ADDENDUM #01

Project Name: Central County Fire & Rescue House #06

Project Number: 24057

Date: July 7, 2026

Sheet No.
A111

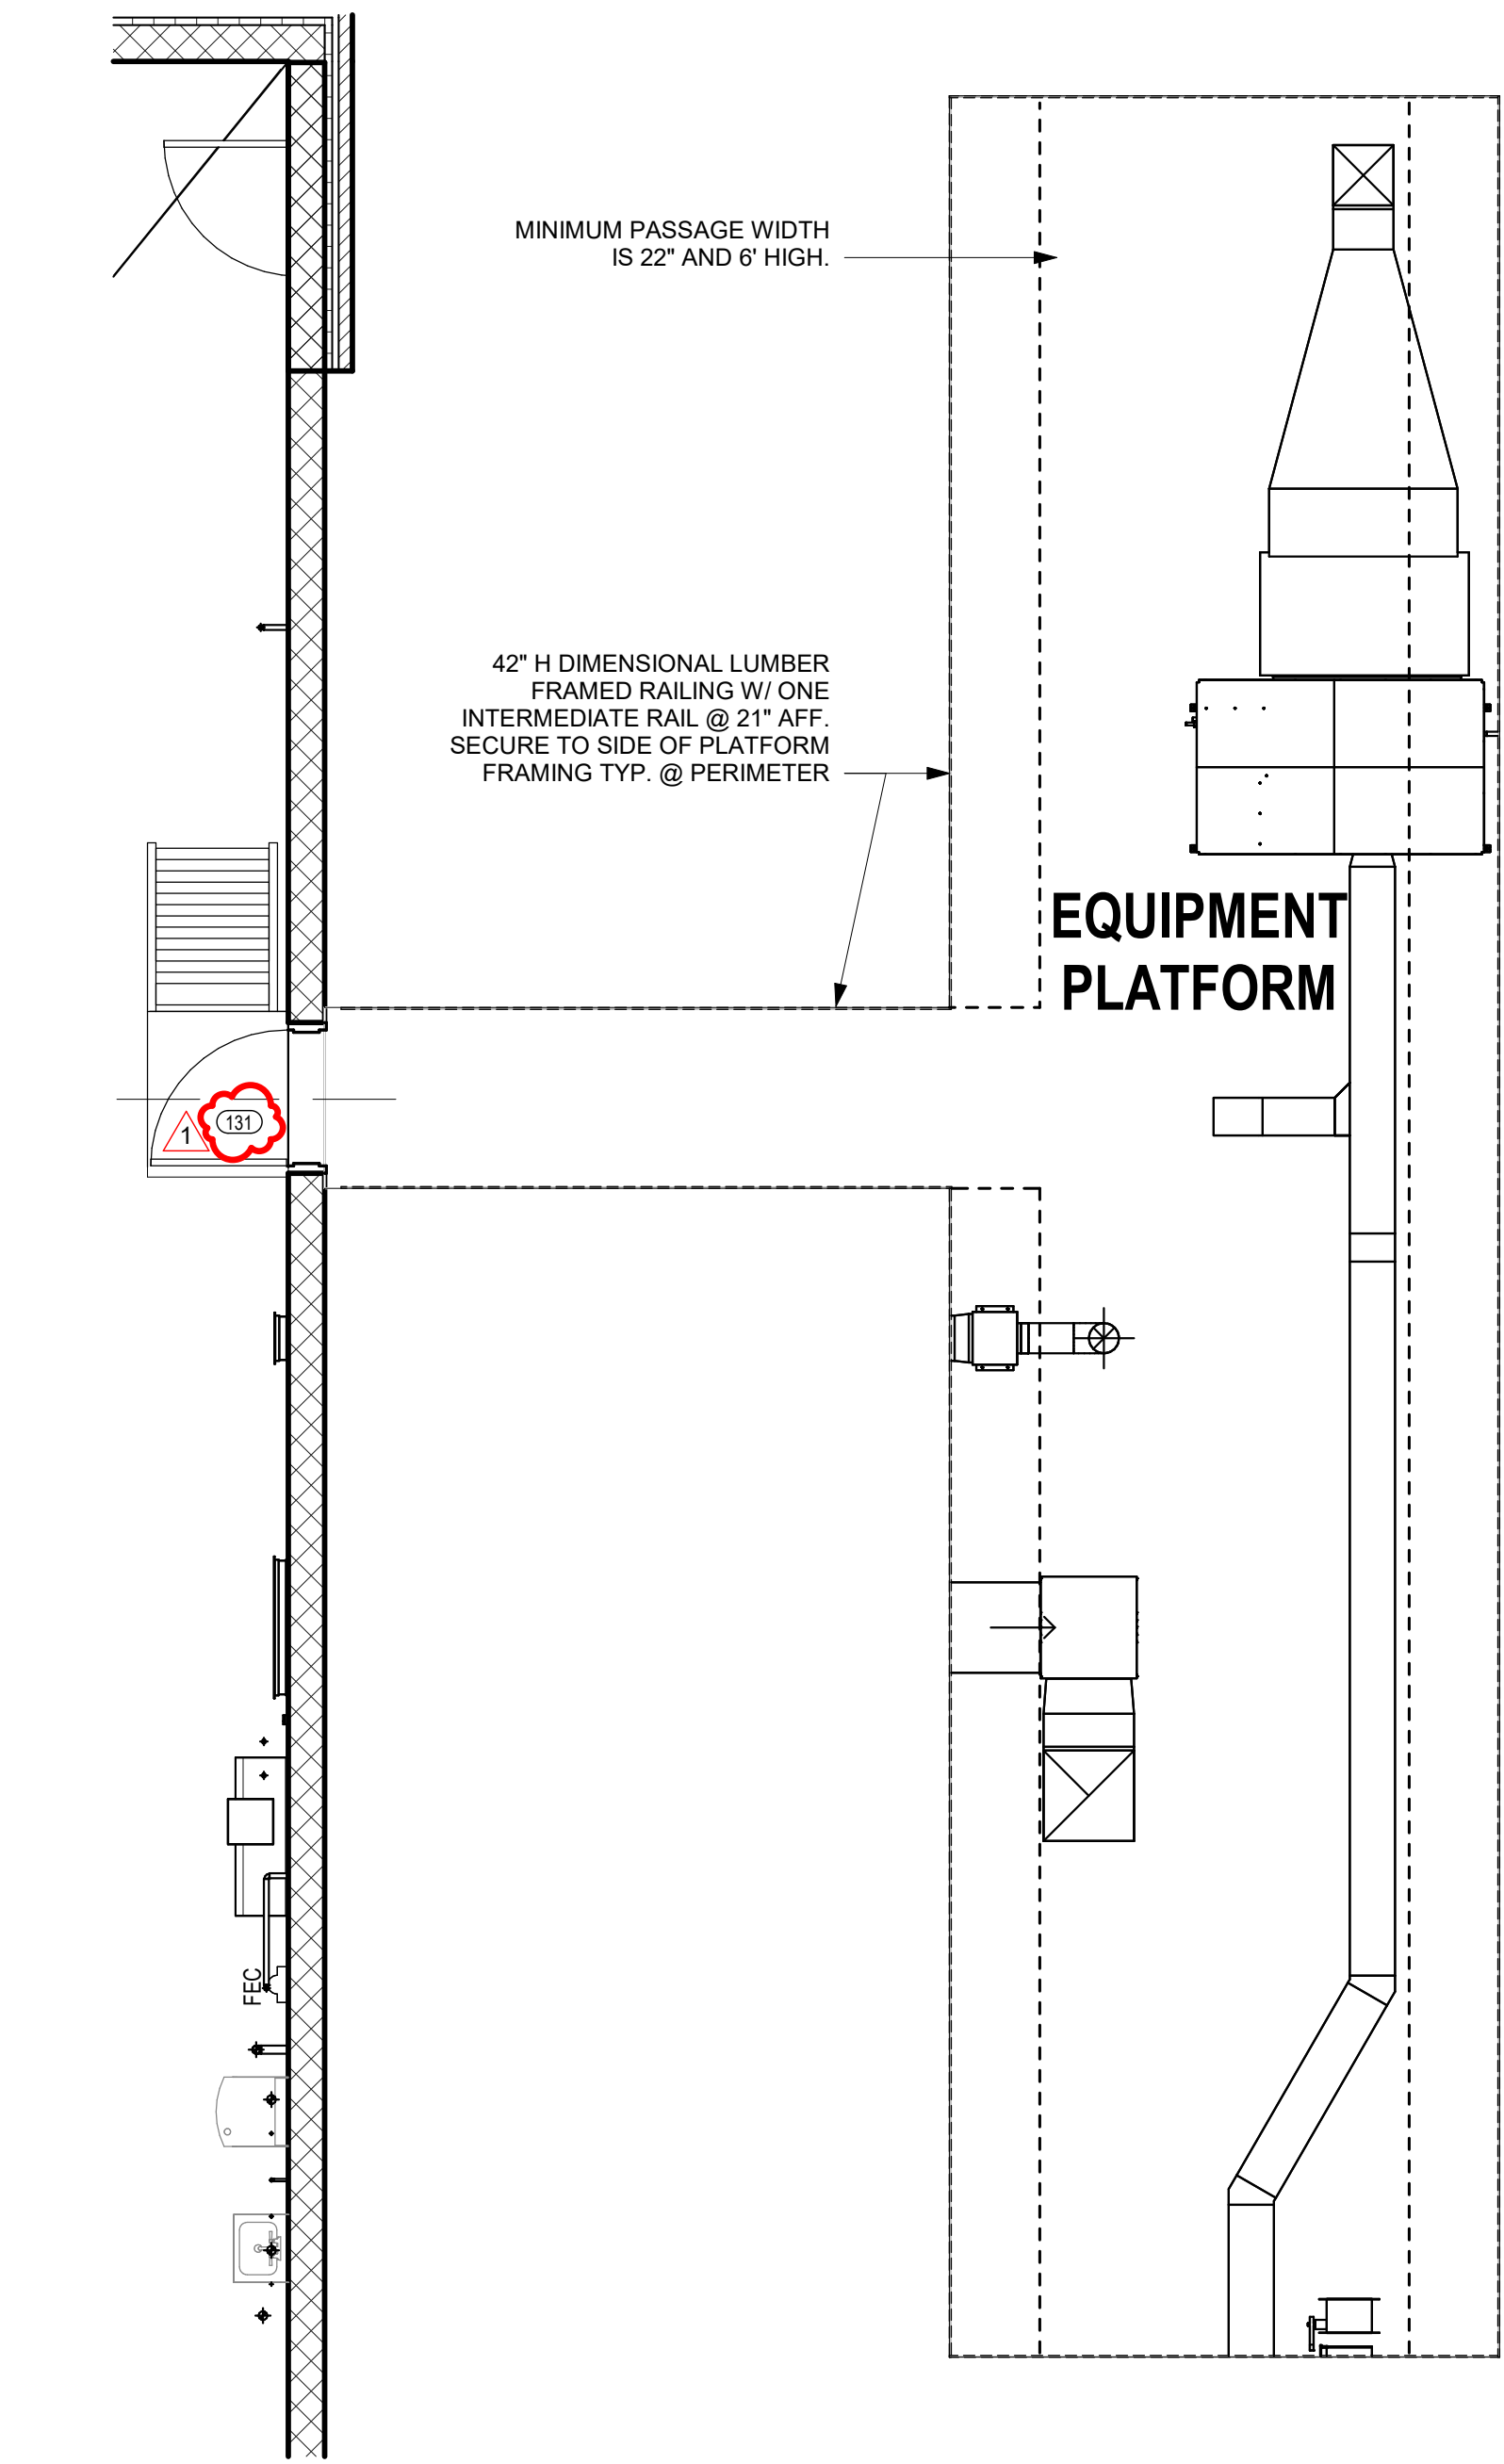
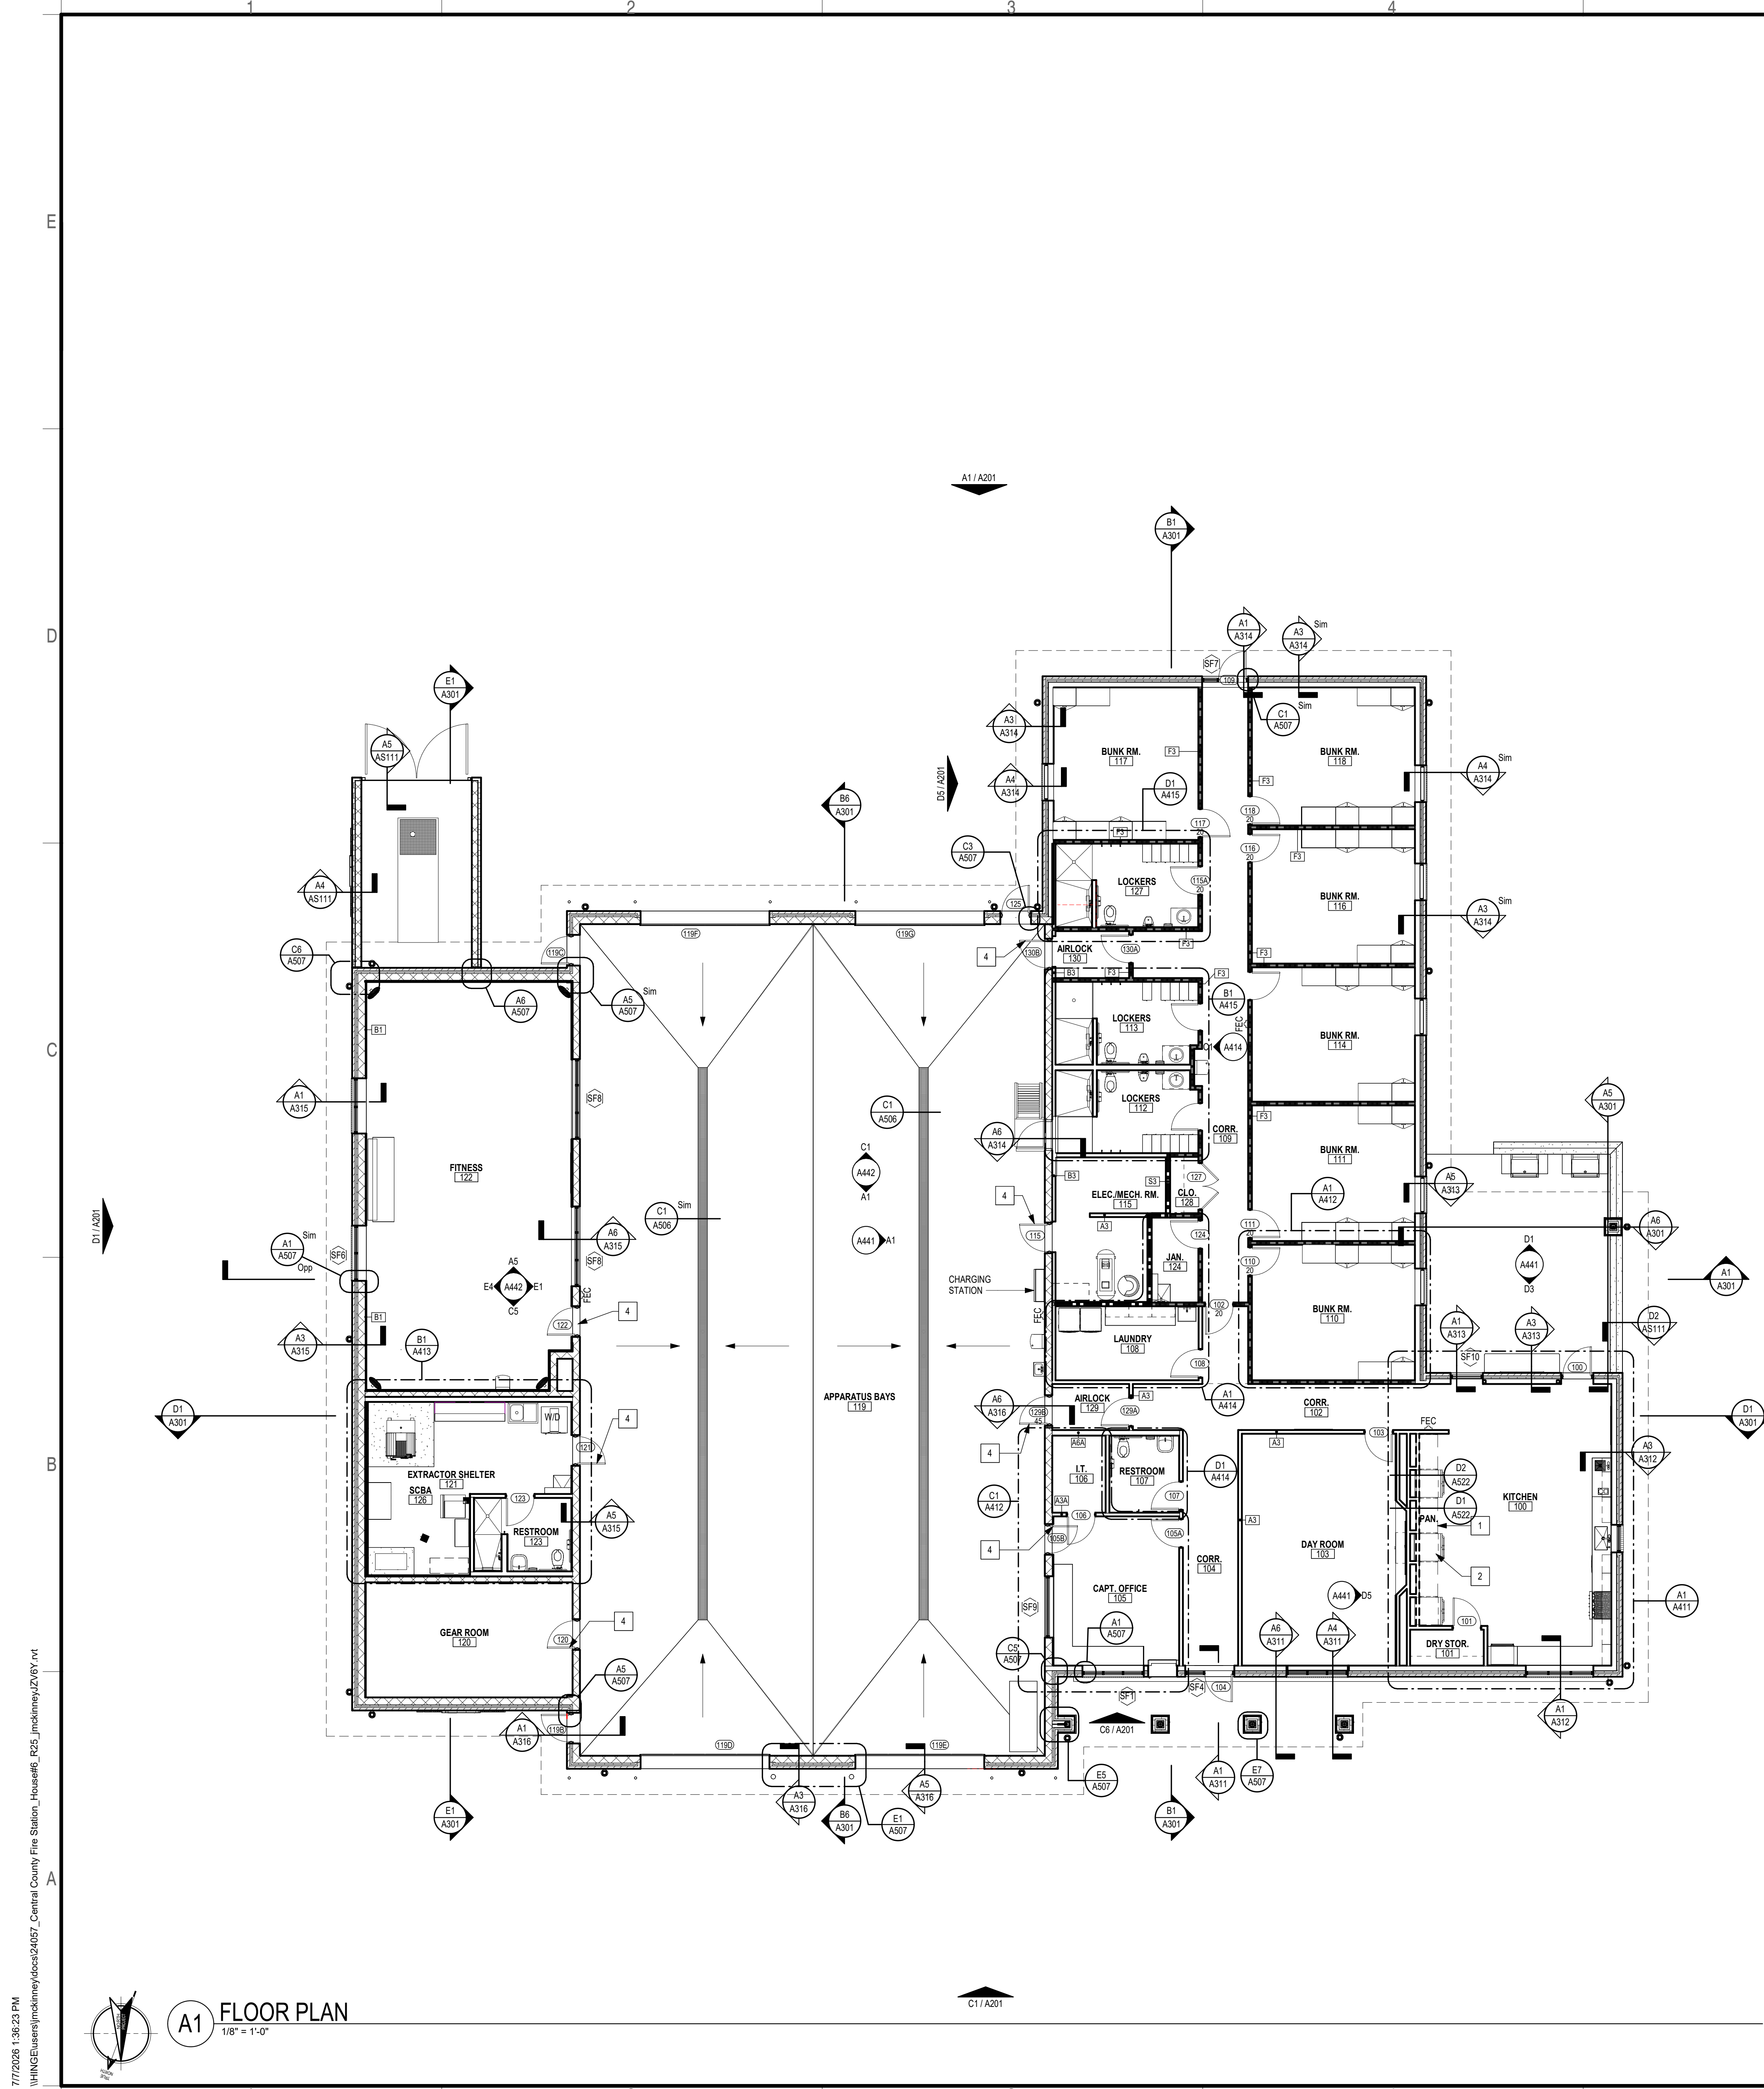
1. Sheet A004: LIFE SAFTETY PLAN
 - a. **Added path to storm shelter, signage legend, 2020 ICC 500 requirements, updated Life safety Plan Legend.**
 - b. **Reference attached Revised Sheet.**
2. Sheet A111: FLOOR PLAN
 - a. **Updated Mezzanine door number on dtl A6.**
 - b. **Reference attached Revised Sheet.**
3. Sheet A201: EXTERIOR ELEVATIONS
 - a. **Updated EXT Bldg. Materials Legend.**
 - b. **Reference attached Revised Sheet.**
4. Sheet A411: ENLARGED FLOOR PLANS
 - a. **Added dimensions to elevations.**
 - b. **Reference attached Revised Sheet.**
5. Sheet A412: ENLARGED FLOOR PLANS
 - a. **Added dimensions to elevations.**
 - b. **Reference attached Revised Sheet.**
